Questions and Answers RFP 25-23 Internal Connections (Hardware)

Photos

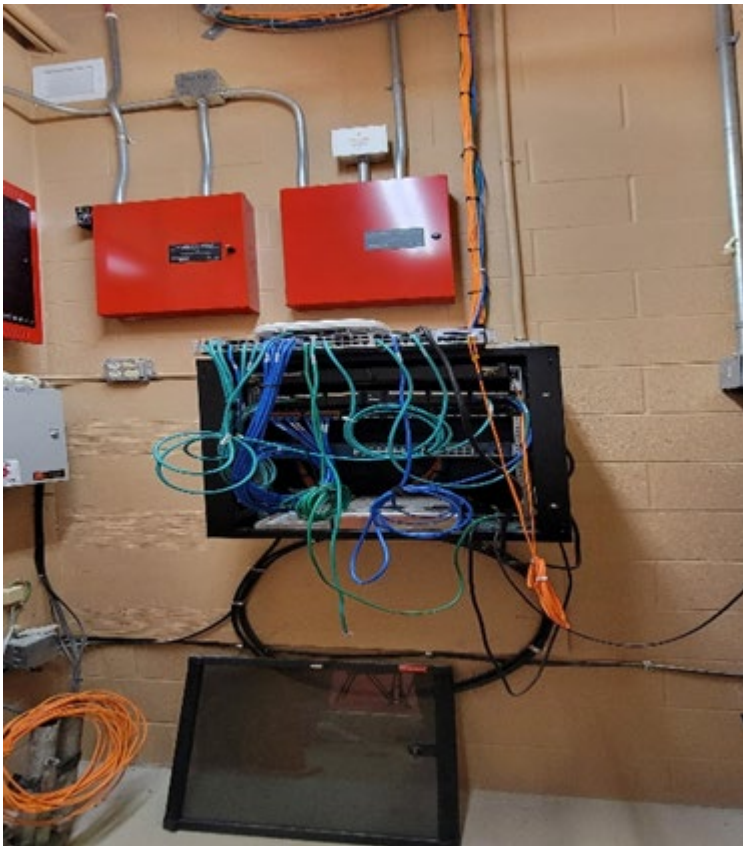
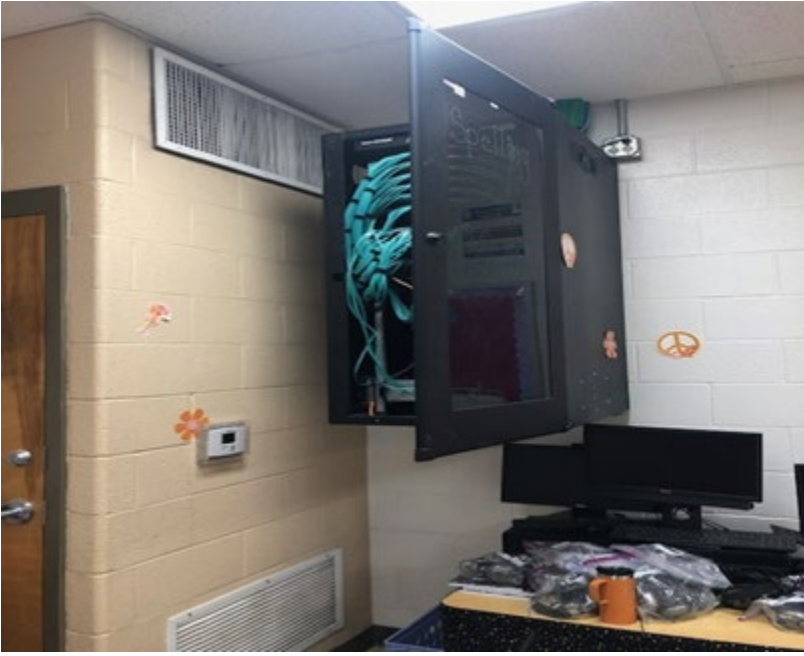
- n. Q: If possible, would you be able to provide pictures of the cabinets plus re-mount points?
A: Yes, see attached photos of the 9 IDF wall mounted cabinets that will be replaced at the four sites. All new wall mounted cabinets will require a mounted backboard for support and safety. See attached photos for reference below.
